**DOS RIOS WRC CHLORINE SYSTEM IMPROVEMENTS**  
**Solicitation Number: CO-00197**  
**Job No.: 17-6508**

**ADDENDUM 3**  
**September 19, 2018**

**FILTER INJECTION PANEL DETAIL**

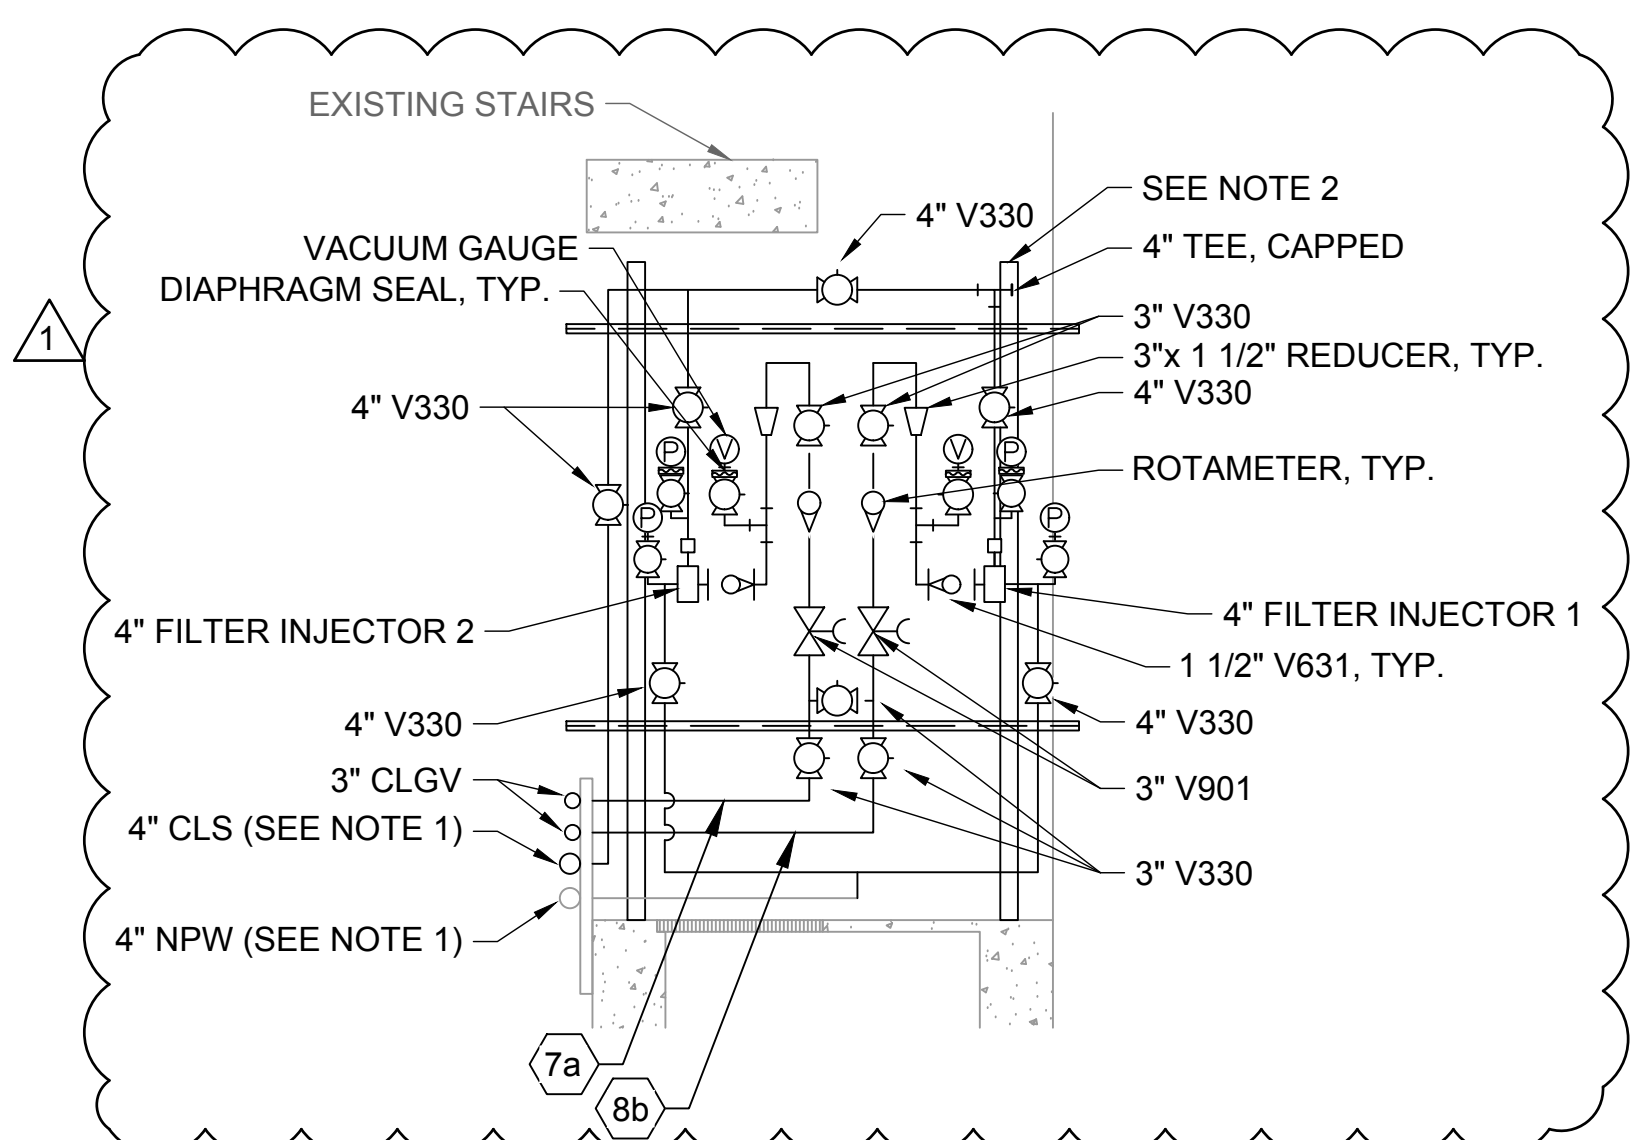
9. **DWG 01-G005: Gauge PI 5-4 is not shown on mechanical plans.**

10. **DWG 01-G005: Plans show this as a diaphragm valve:**

**Response:** This gauge has been added to revised DWG 05-C501, Detail 6, issued in this addendum.

**Response:** This is intended to be a ball valve. Valve call-outs have been updated on revised DWG 05-C501, Detail 6, issued in this addendum.

DRAWING NUMBER  
**10-M131**  
SHEET NUMBER  
**62**

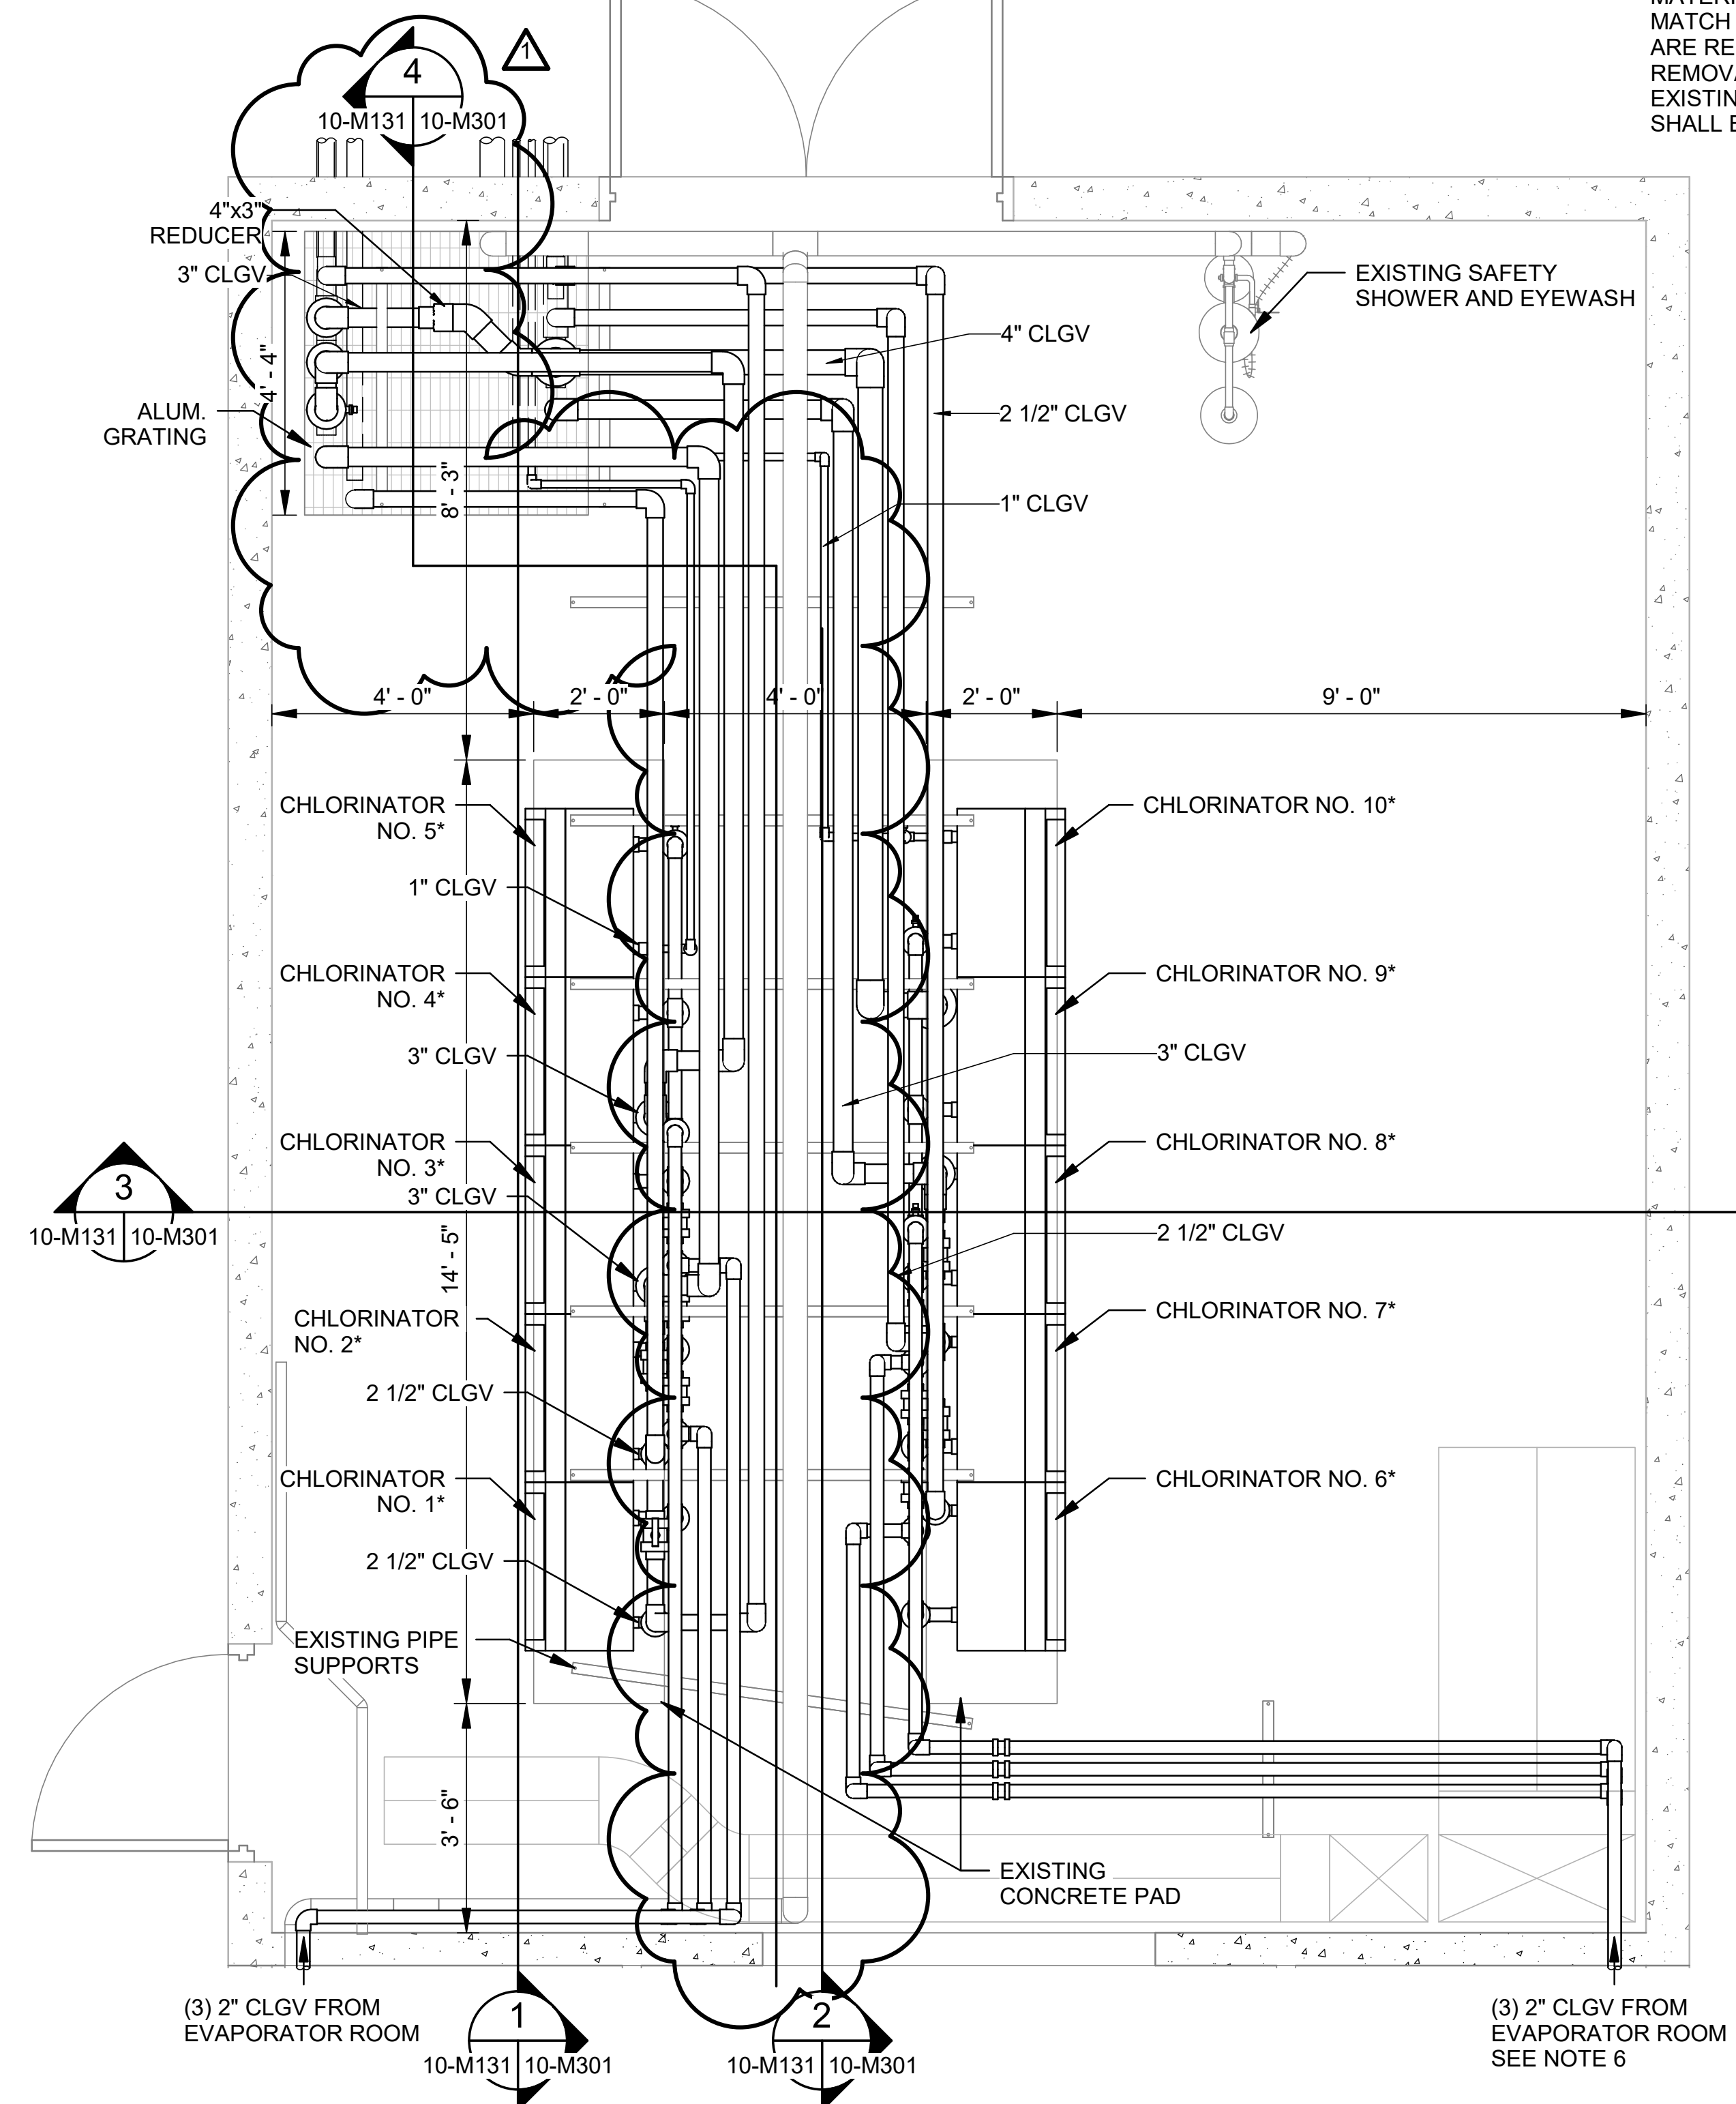
18. DWG 10-M131: What is this? Nothing shown on P&ID.

20. DWG 10-M131: Please label all Evaporator Room Piping.

**Response:** This is a gas strainer that would be supplied as part of the Chlorine Equipment Manufacturer’s vacuum regulating unit package. Its location has been adjusted as shown in revised drawings 01-G004, 01-G005, 10-M131, 10-M302, and 10-M503 issued in this addendum.

**Response:** Piping labels have been added to representative evaporators on the revised DWG 10-M131, issued in this addendum.

DRAWING NUMBER  
**20-X102**  
 SHEET NUMBER  
**103**

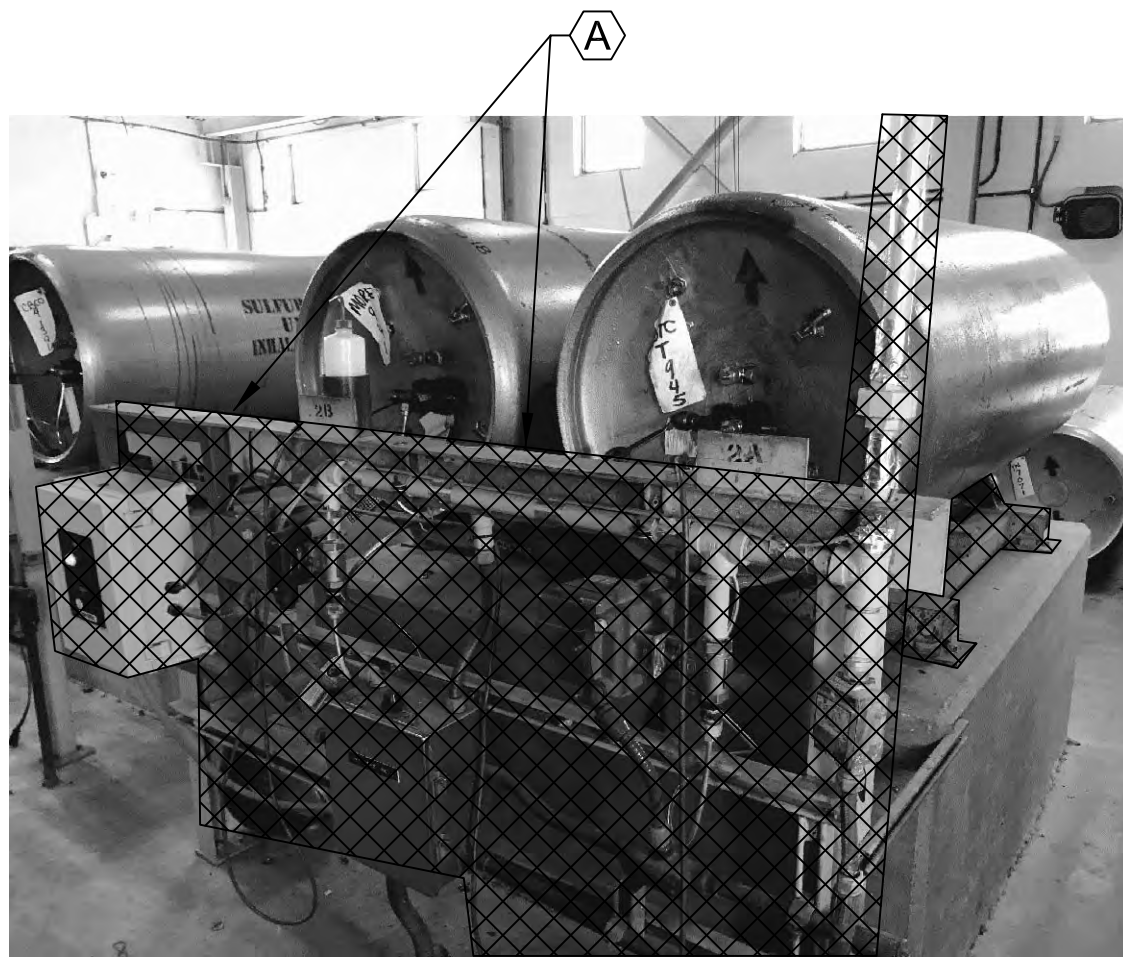
- c. Correct top continuation legend on the left schematic from "Continued Below left" to "Continued from 10-E507"
39. Sheet 20-X102
  - a. Replace the sheet with the attached. Changed callout on Section 4 from "Reuse Existing Scale" to "Remove Existing Dual Cylinder Scale".

DRAWING NUMBER  
**20-M131**  
 SHEET NUMBER  
**110**

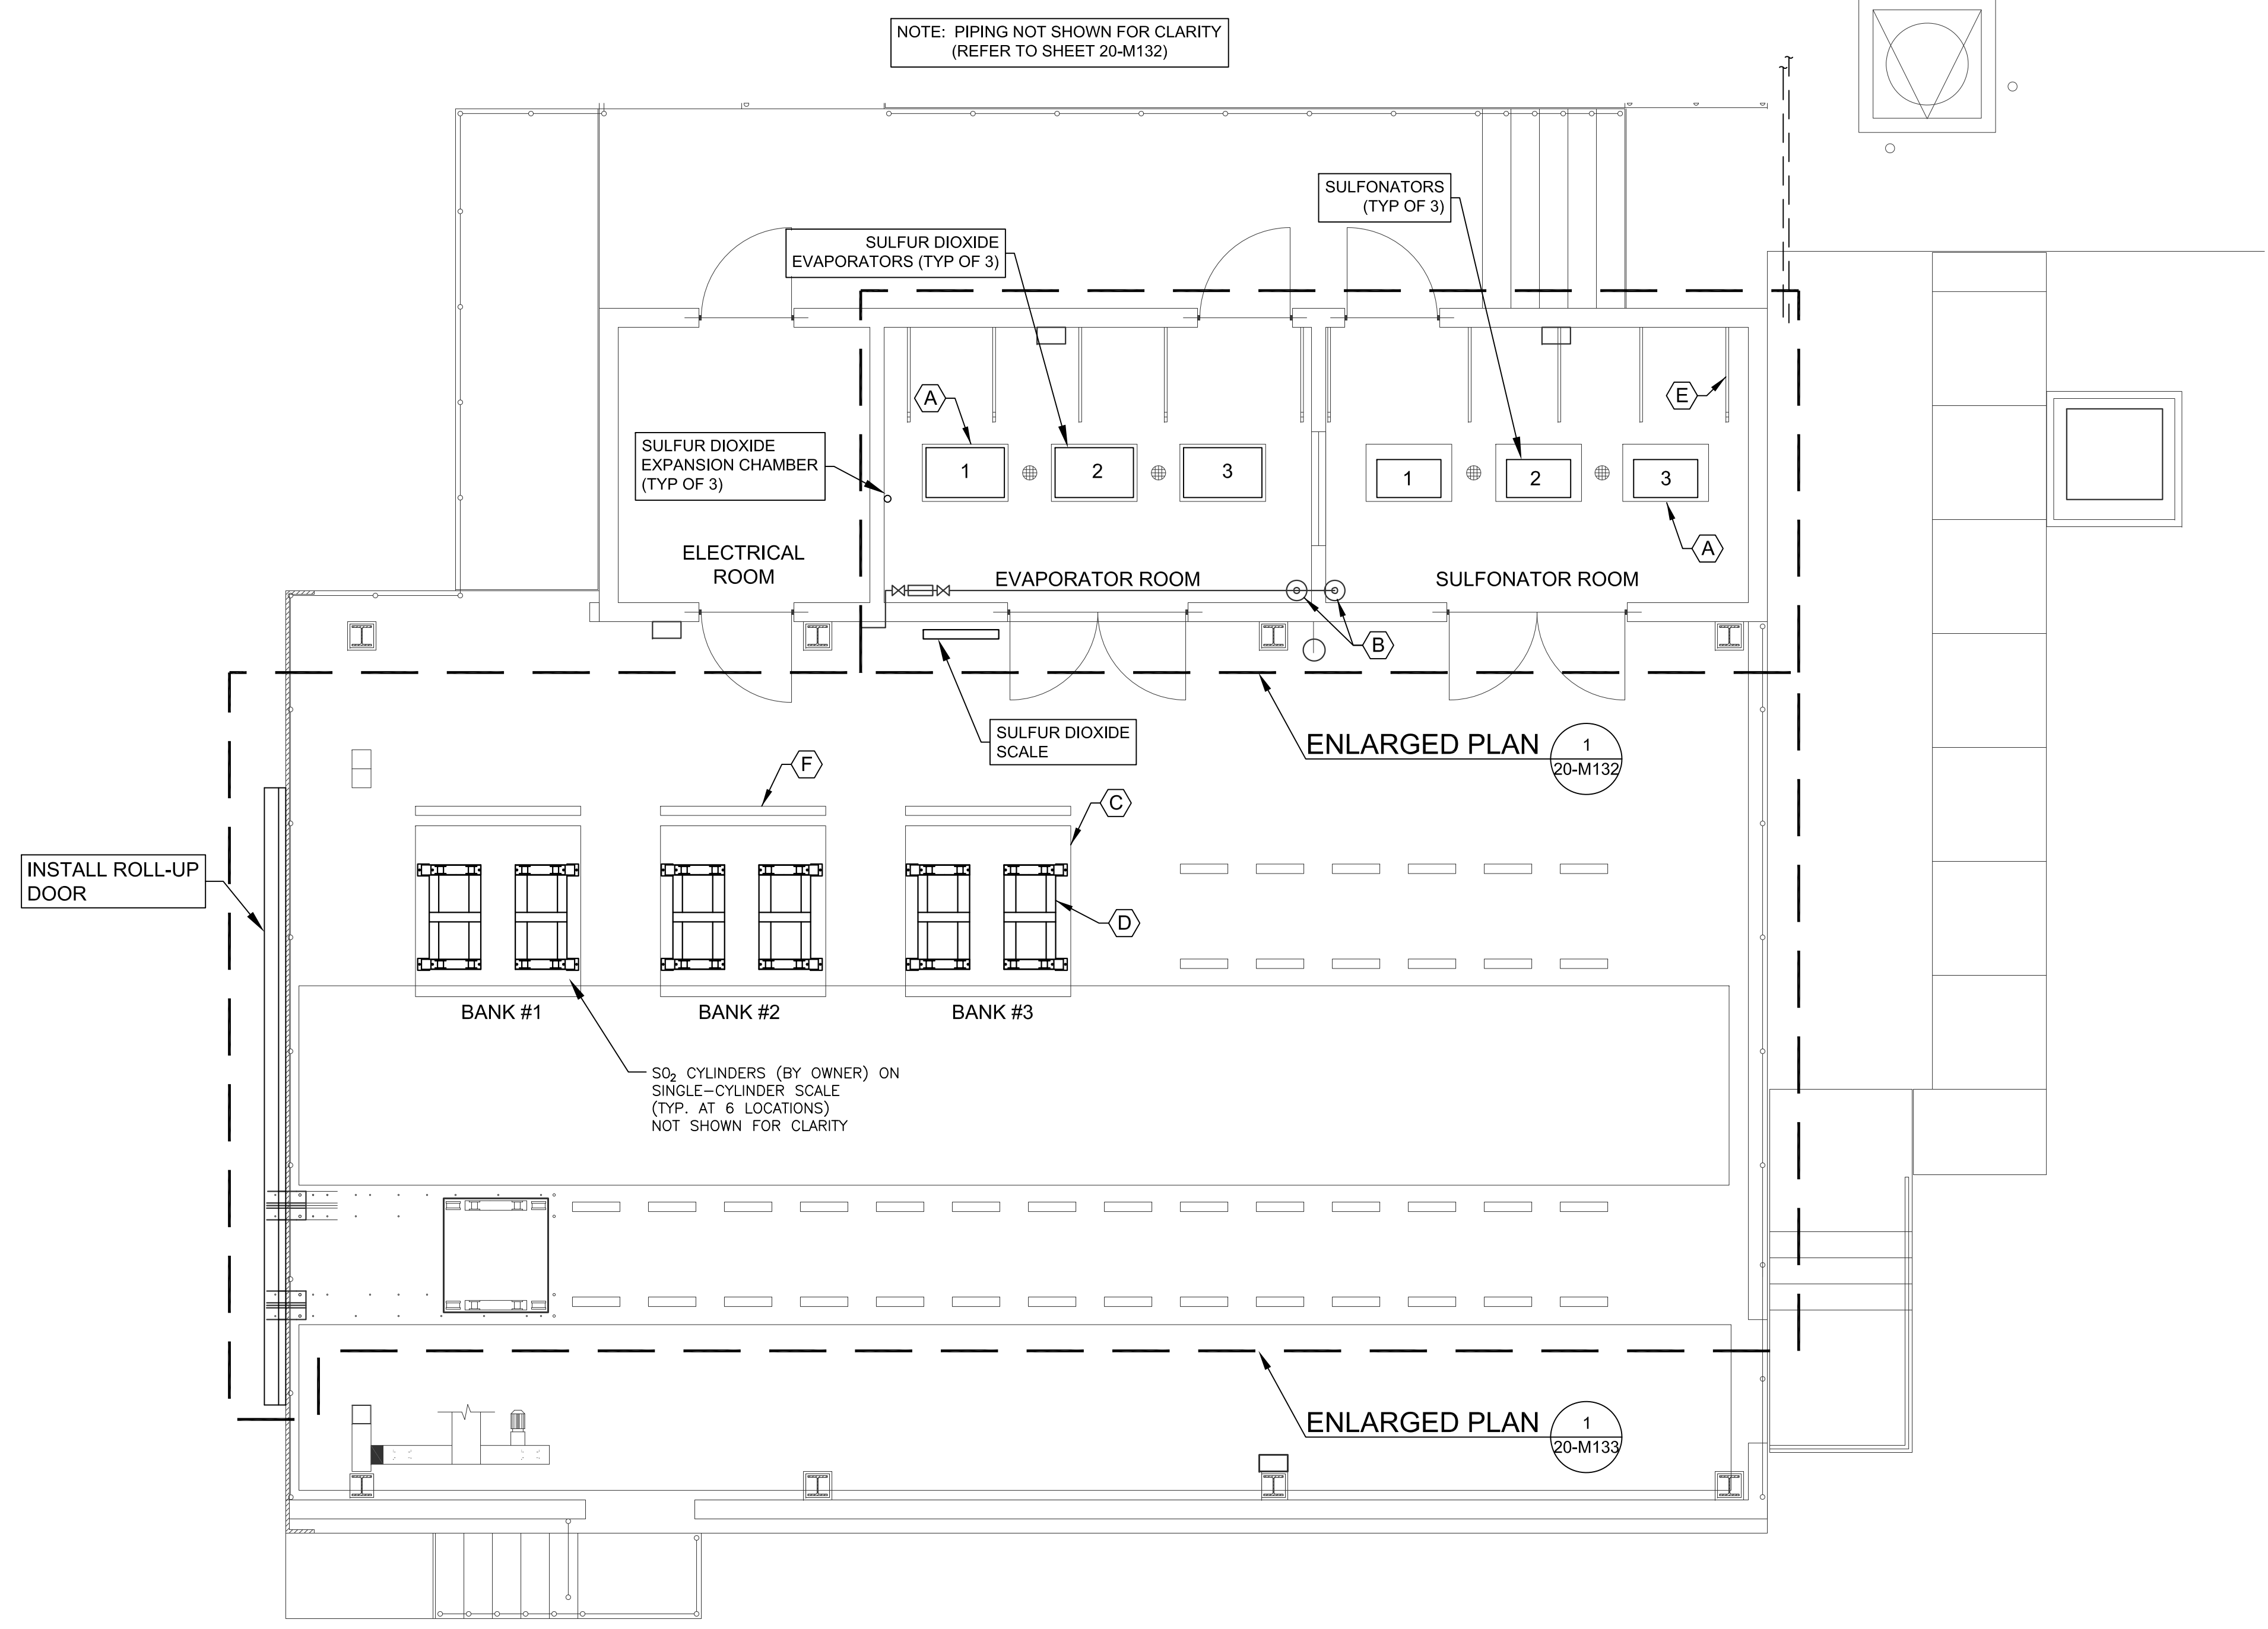
41. Sheet 20-M131
  - a. Replace the sheet with the attached. Modifications are summarized as follows:
    - Added callout to show location of new SO<sub>2</sub> Cylinder Room Roll-Up Door.

- Deleted callout "Re-Use Single-Cylinder Scale (Typ. Of 3)".
    - Changed Key Note D from "Existing Single Cylinder Scale (To Remain)" to "Existing Dual Cylinder Scale (Remove and Replace with New Scales)".
